ADDENDUM NO. 1

Hamilton County Department of Education
Dalewood Middle School Re-Roofing (Phase 1)
Derthick Henley & Wilkerson Architects

Date: January 12, 2023
HCDE Bid No. 23-15
DHW Project No. 82211-B

Project Area Key Plan
1
G000 1" = 40'-0"

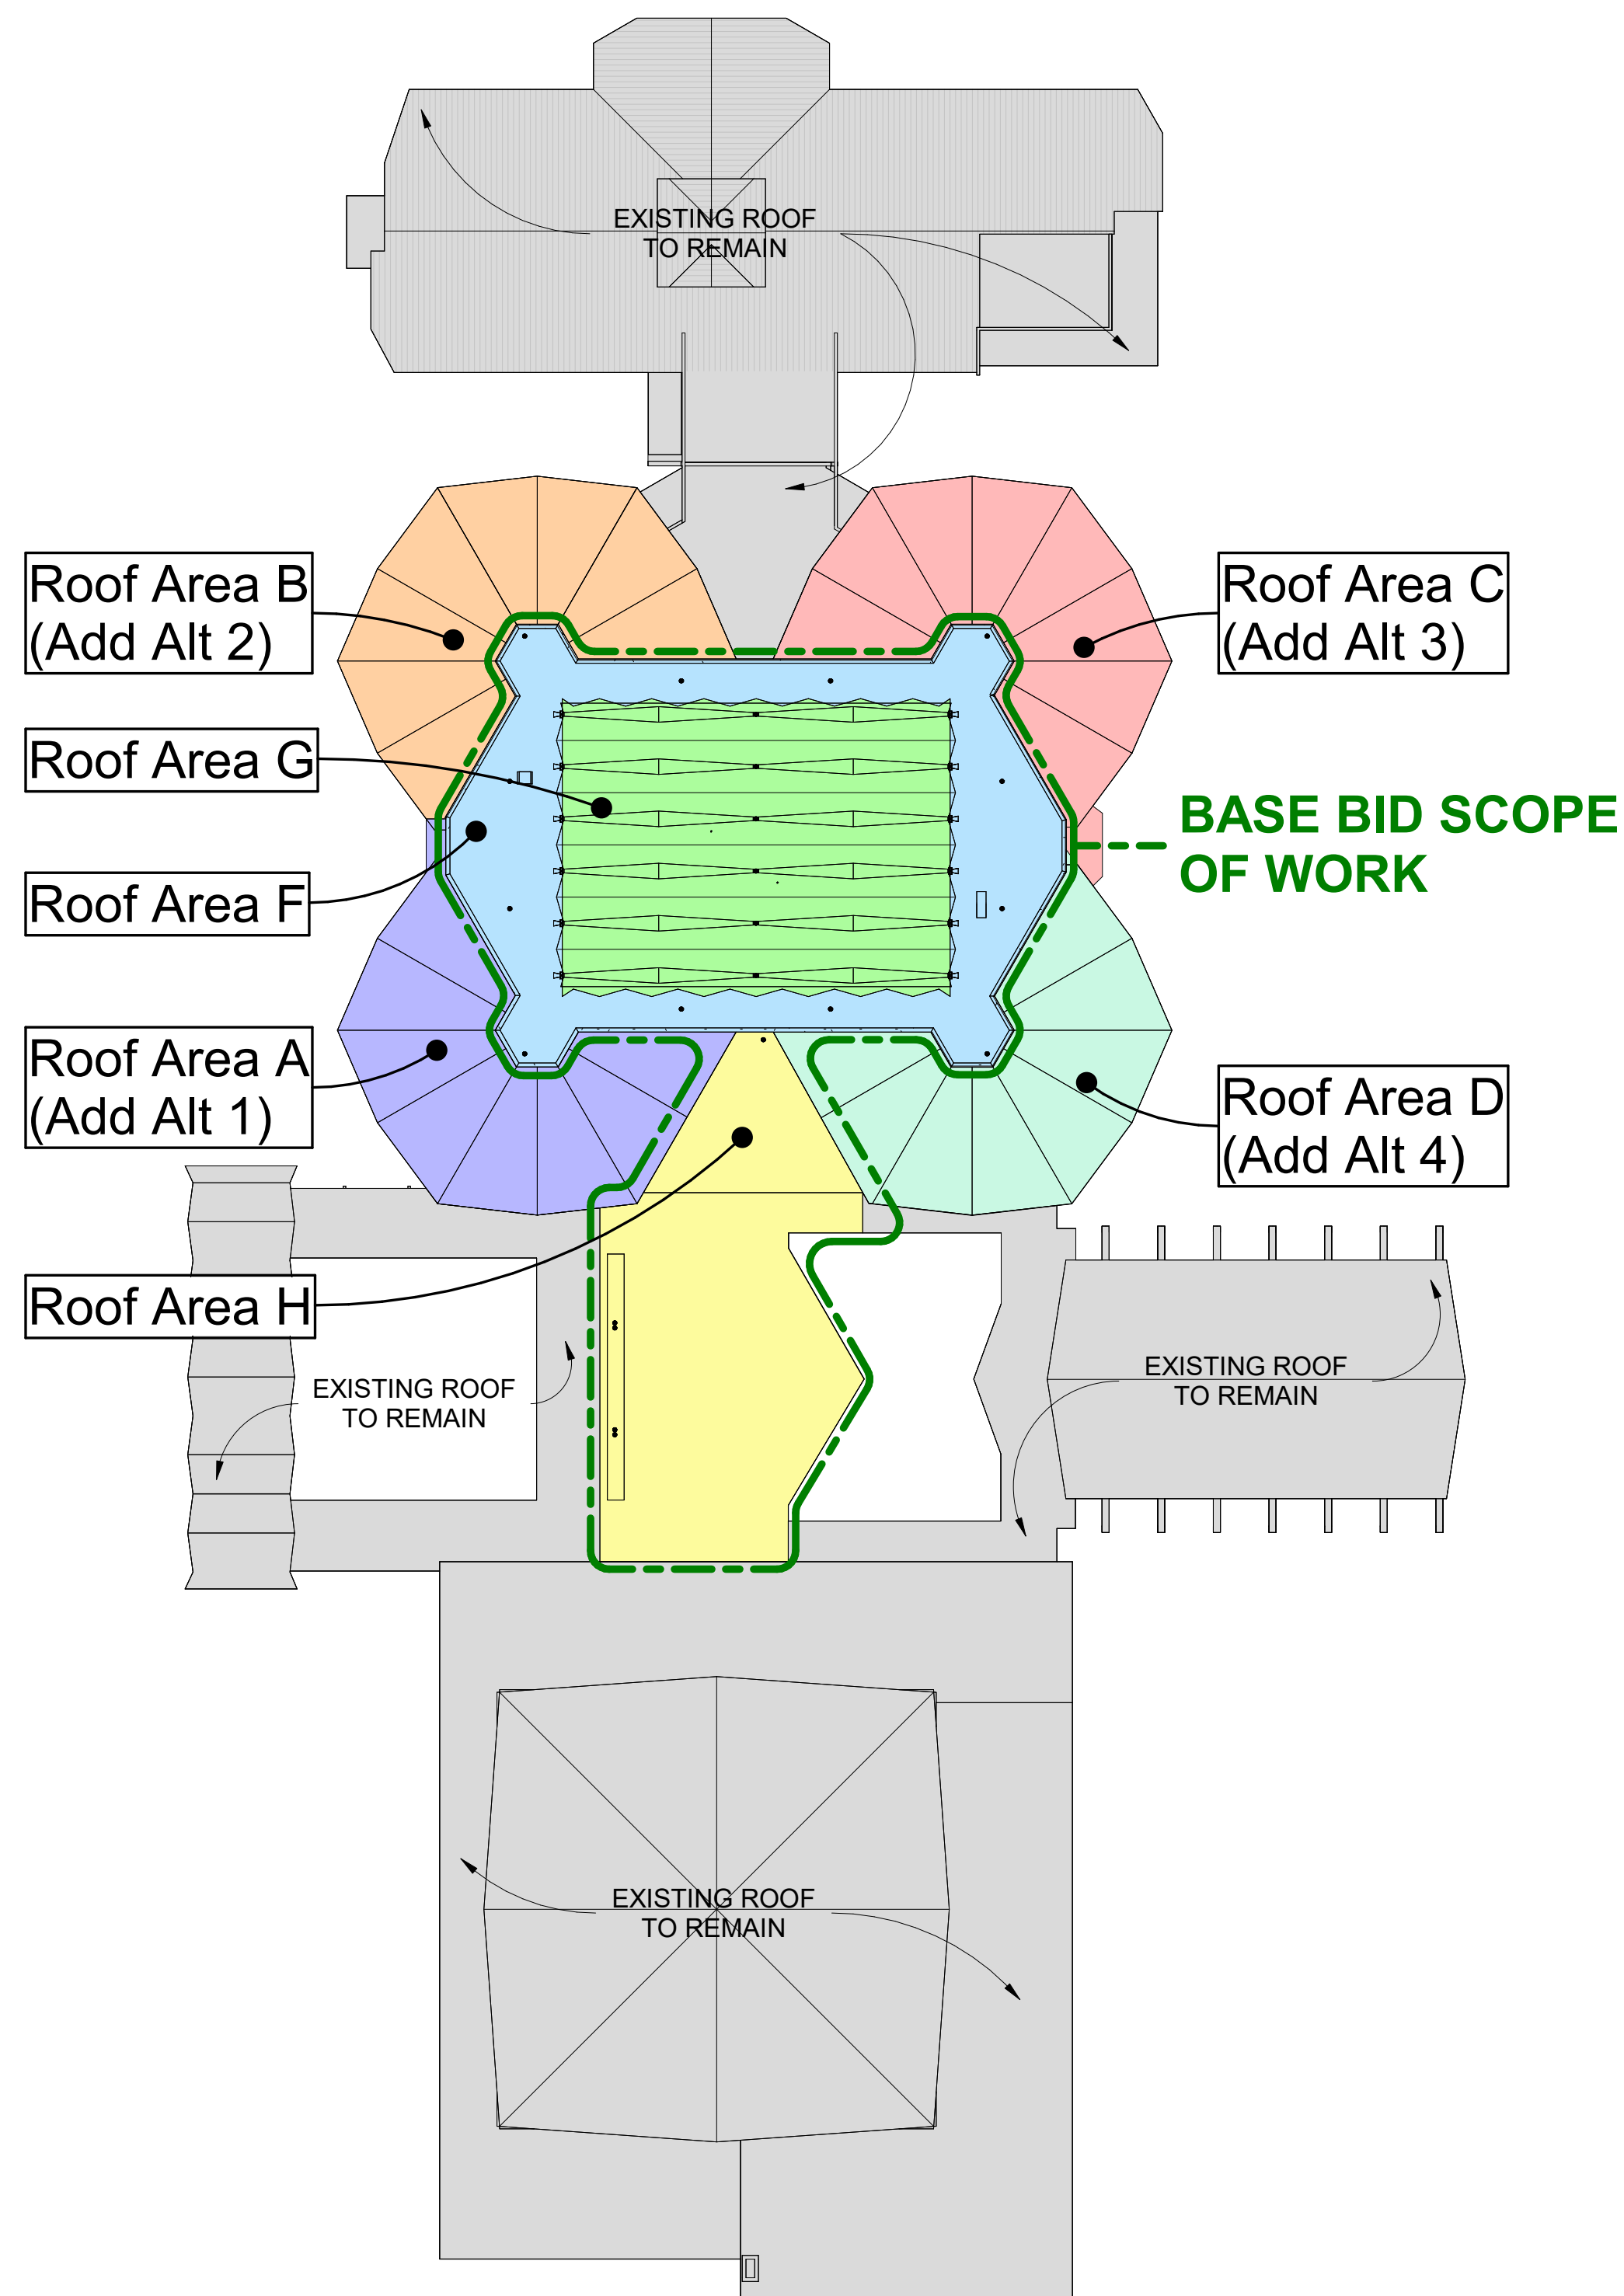
Sheet with clouded revisions issued as part of this Addendum.

Scale:
 Sheet No. **A100**

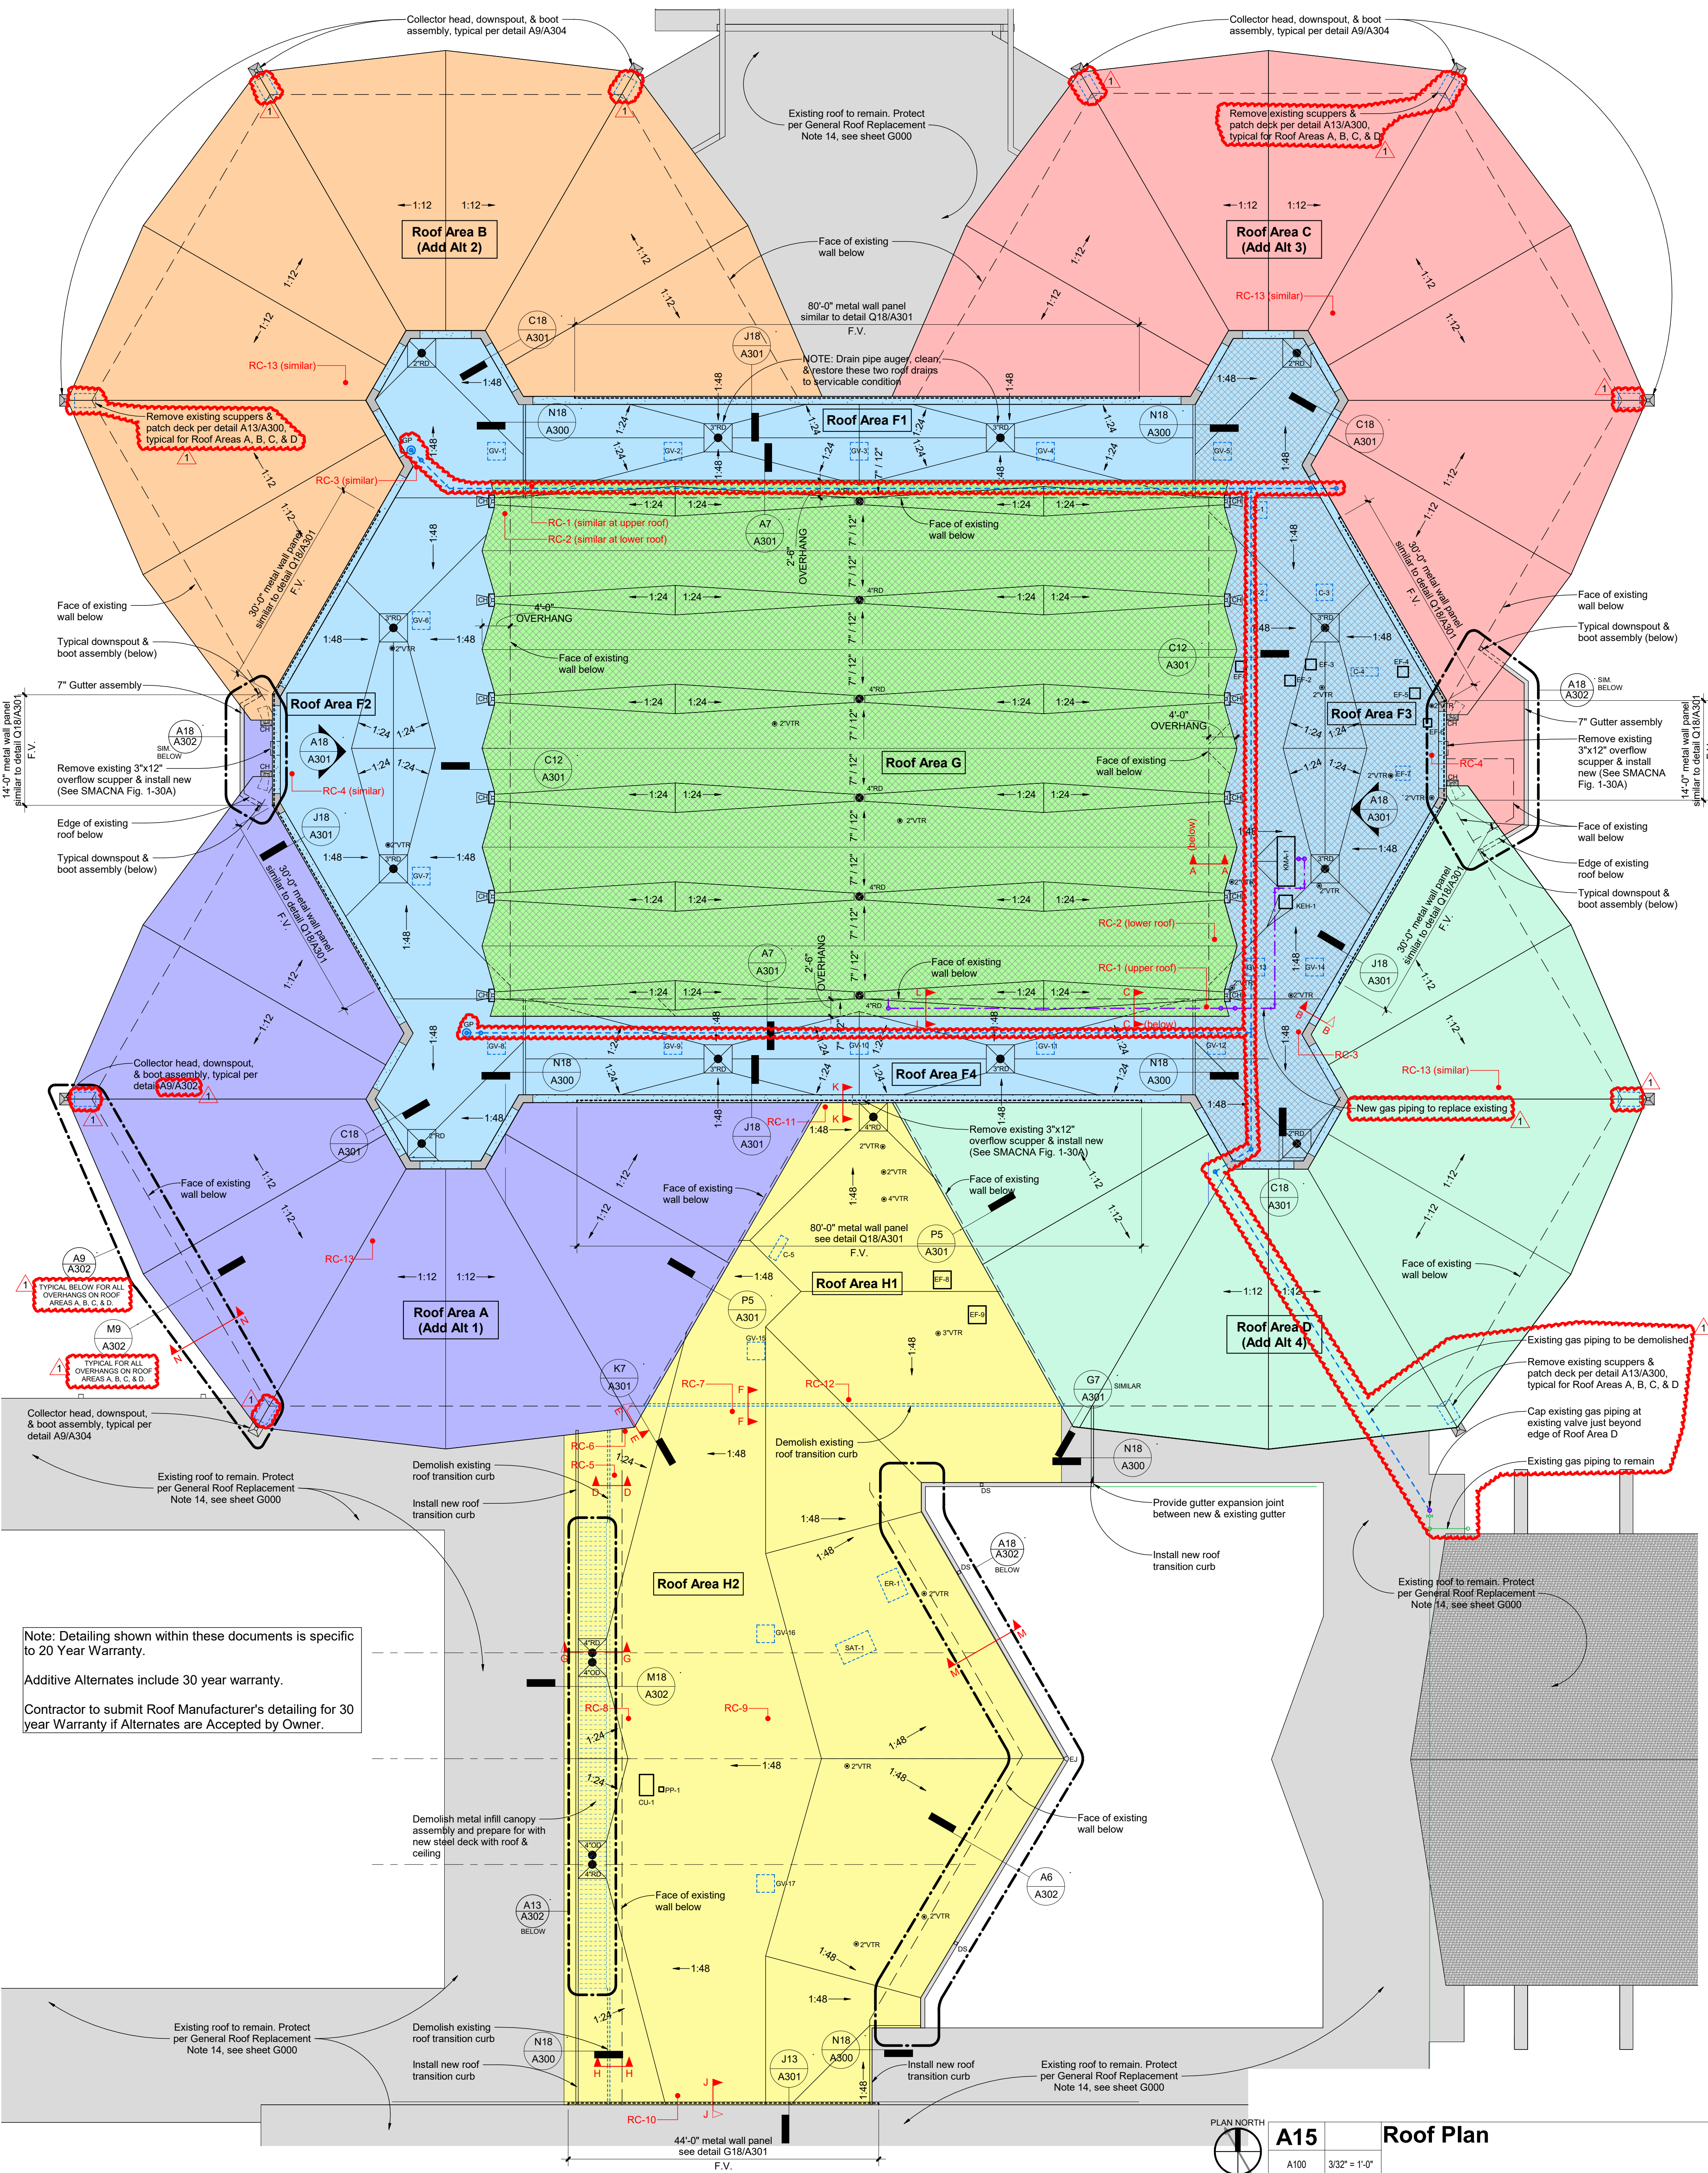
Sheet with clouded revisions issued as part of this Addendum.
